ARCHITECTURAL REVIEW BOARD

LOCATION: Northwest corner San Juan Road & Truxel Road

PROPOSAL: 218 New Housing Units, ARB Review of Exterior Elevations

APPLC. NO. 82-128

(BLDG. CLUSTER)

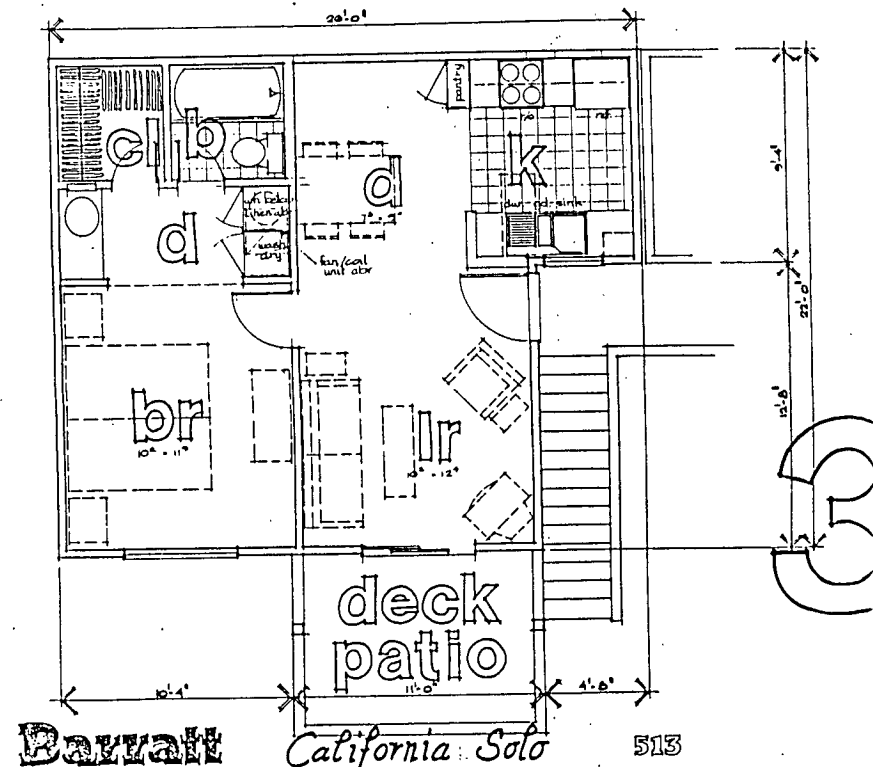
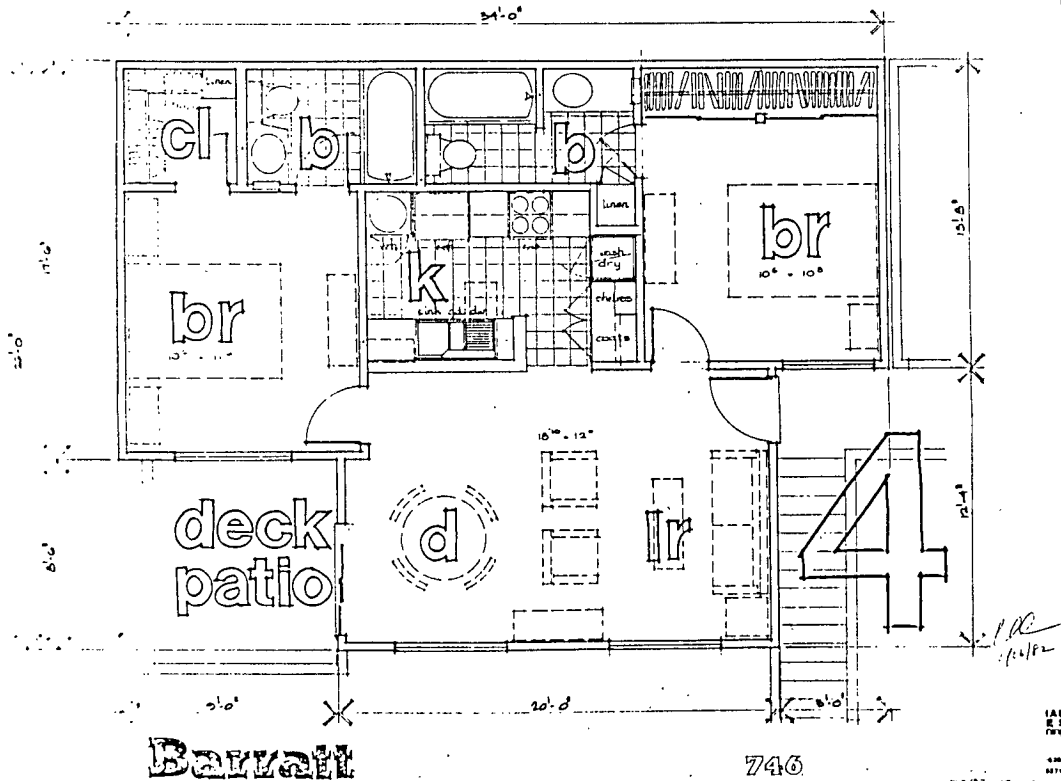
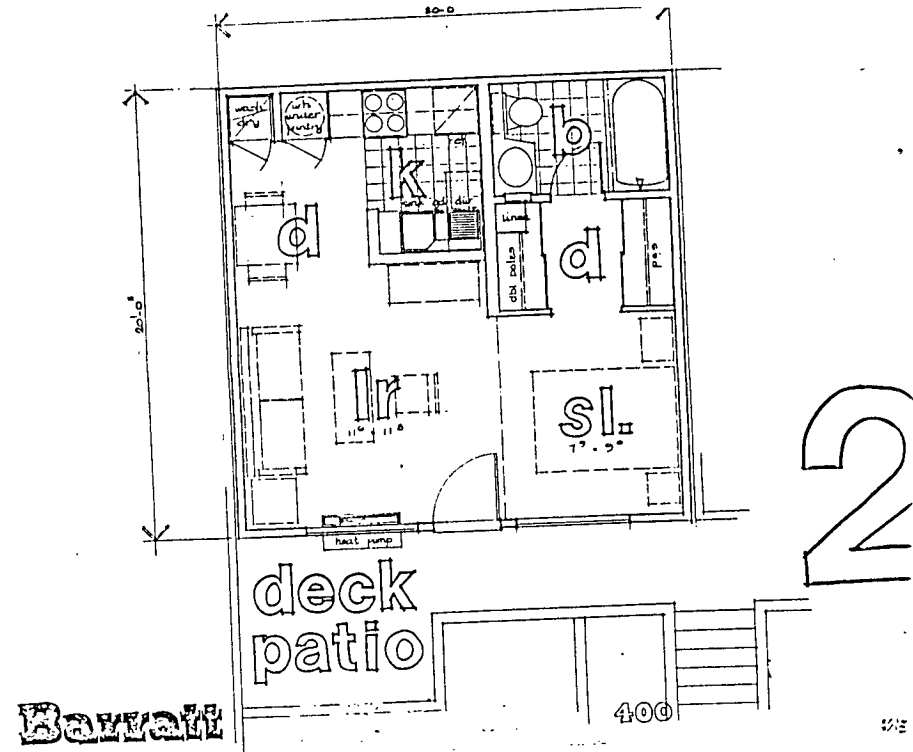
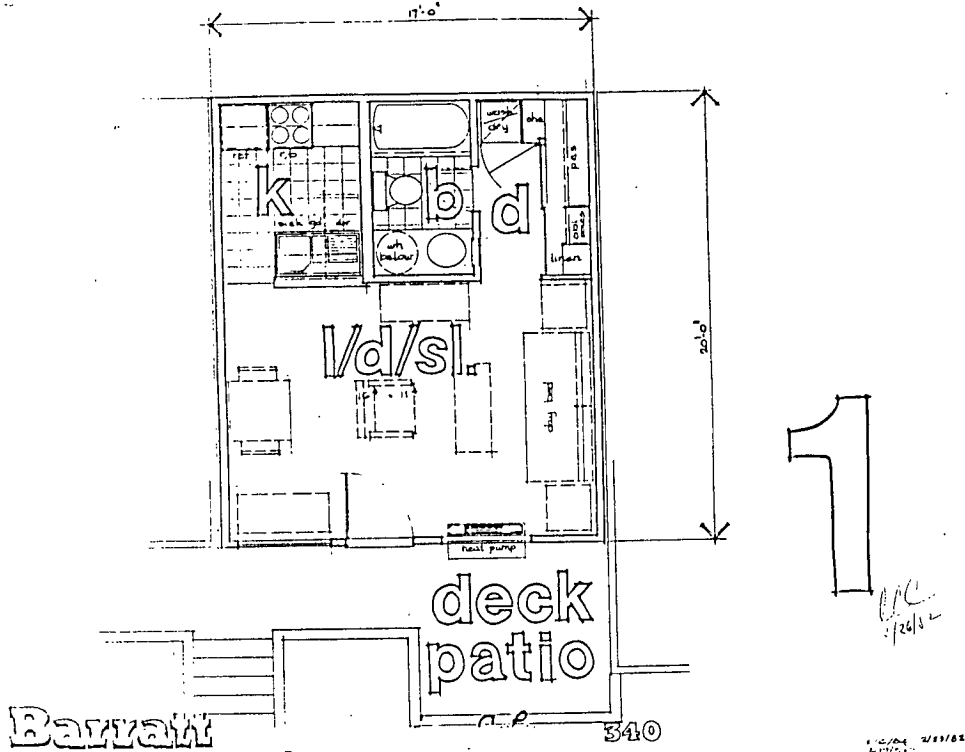
1. Staff feels that a change in wall treatment would be appropriate on those elevations where no window or door openings are proposed. Staff feels that a horizontal siding painted the same color as the stucco would be appropriate. This would allow a change of texture and yet keep the color scheme the same. Horizontal siding should not be any more expensive than stucco.

2. Staff feels that a portion of each of the deck areas railings should be in solid material. This would serve as a screening devise to hide miscellaneous patio items which are usually stored outdoors. This would provide an attractive alternative to the usual visual blight that is found on these type of deck areas.

3. Staff feels that each deck area should have some type of overhead cover. Either as part of the permanent construction of the building or in the form of canvas awning. Many of the decks as proposed do have a cover provided. All ground level decks are covered over by the deck of the second floor patio. Only some second floor patios are not provided with a covering devise. Staff feels that is important for a feeling of enclosure to provide some overhead protection from the sun and rain and to give an indication of some privacy.

4. Staff feels that the decks could further provide a sense of enclosure and privacy in those areas where the deck is only adjacent to one wall of the structure. Staff feels that a wing wall extending out from the face of the building and running up the width of the deck from ground to roof line would provide, not only a sense of enclosure for the deck areas, but also would provide a design element on the exterior of the building.

1. The applicant will provide horizontal siding painted the same color as the stucco on the walls of the structures which do not have window or door openings.
2. The applicant will provide overhead roofing or awning over all deck areas.
3. The applicant will provide some solid railing areas on each deck to be used as screening in order to hide stored items from public view.

4. The applicant will provide a vertical wing wall extending out from the surface of the building adjacent to each deck where that deck is now only adjacent to one wall surface of a building.
5. Final irrigation and landscaping plans will be returned to staff for review and approval.
